DESIGN <i>PH</i>	DRAWN BY <i>PH</i>	DART AEROSPACE LTD HAWKESBURY, ONTARIO, CANADA	
CHECKED <i>[Signature]</i>	APPROVED <i>[Signature]</i>	DRAWING NO. DSI 9328	REV. A SHEET 1 OF 1
DATE 06.04.20		TITLE RUN-ON LANDING WEARPLATE KIT	SCALE NTS
A	06.04.20	NEW ISSUE

DART SERVICE INSTRUCTION

TO AMEND INSTALLATION INSTRUCTIONS D205-564 Rev. D / IIN-D430-688 Rev. B
REF. CANADIAN STC: SH96-42 / SH01-56
REF. FAA STC: SR00571NY / SR01404NY

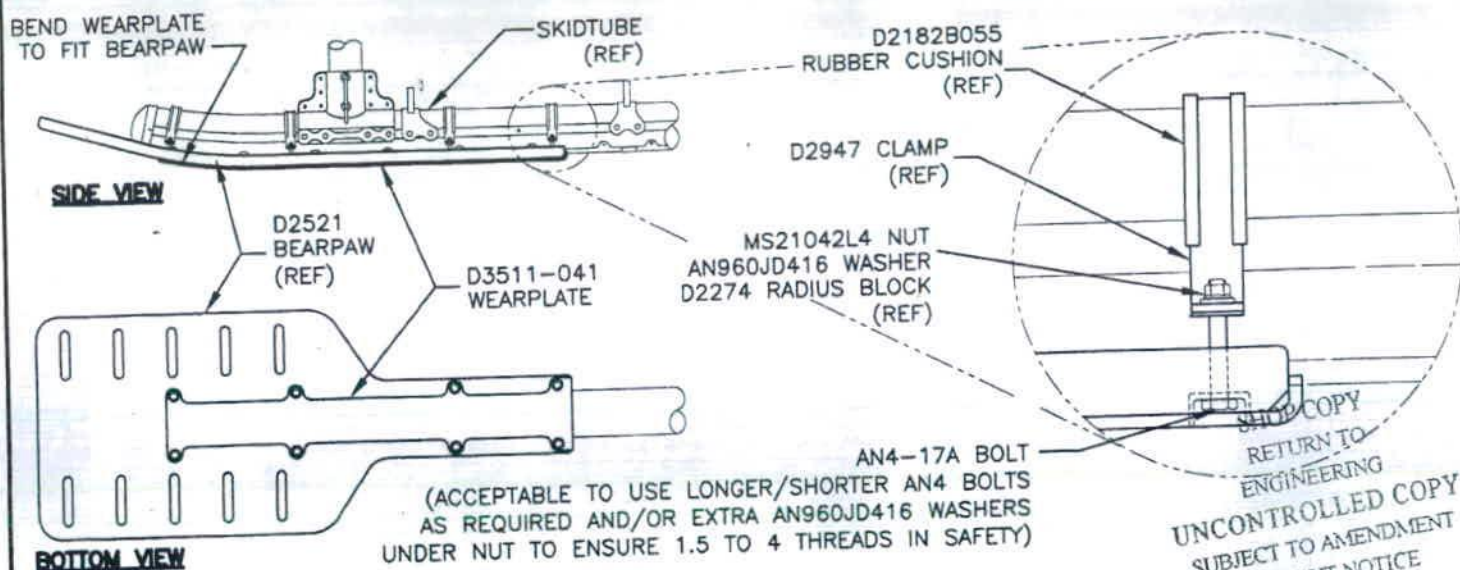
The DSI-9328-011 Run-on Landing Wearplate Kit can be installed on Dart D205-564-011 / D430-688-011 Bearpaw Installations (kit K10015 Change 002 or later only). Earlier model bearpaws can be made compatible with DSI-9328-011 kit by opening up counter bores to Ø0.930. The wearplate kit includes two stainless steel wearplates that fit to the bottom of the Dart Bearpaws. Install the wearplates as shown below. Note that the D2529 washers are not required when the D3511-041 wearplates are installed.
